Summary of Changes
ITS Chapter 4.0

KEWAUNEE POWER STATION IMPROVED TECHNICAL SPECIFICATIONS CONVERSION

ITS CHAPTER 4.0 DESIGN FEATURES

Revision 1

FIGURE TS 5.4-1

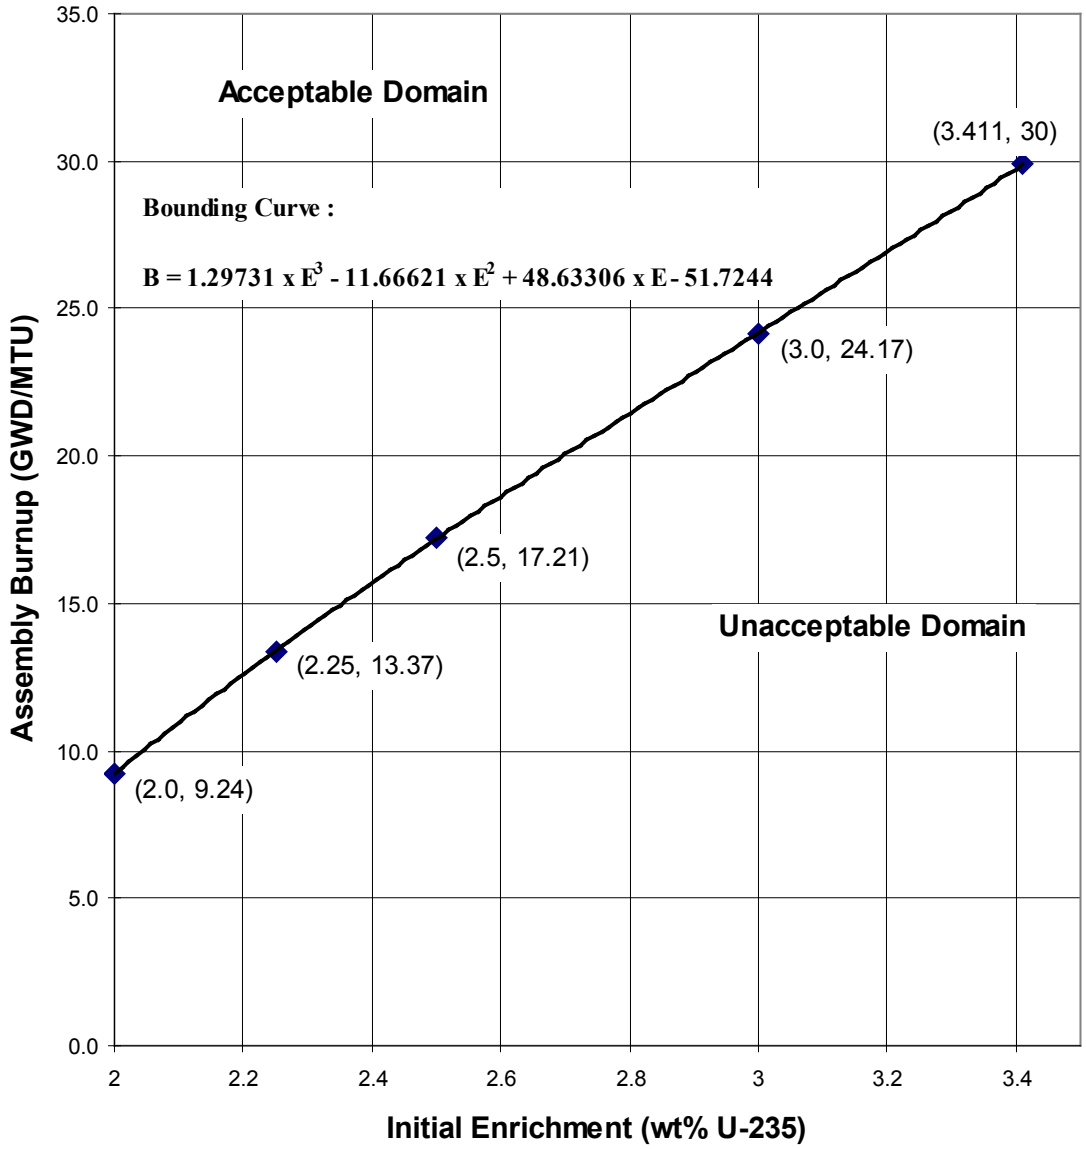
Fuel assemblies stored in the canal racks shall meet the minimum required fuel assembly burnup as a function of nominal initial enrichment as shown in Figure TS 5.4-1. These assemblies shall also have been discharged prior to or during the 1984 REFUELING outage. — See ITS 3.7.15

See ITS 3.7.15
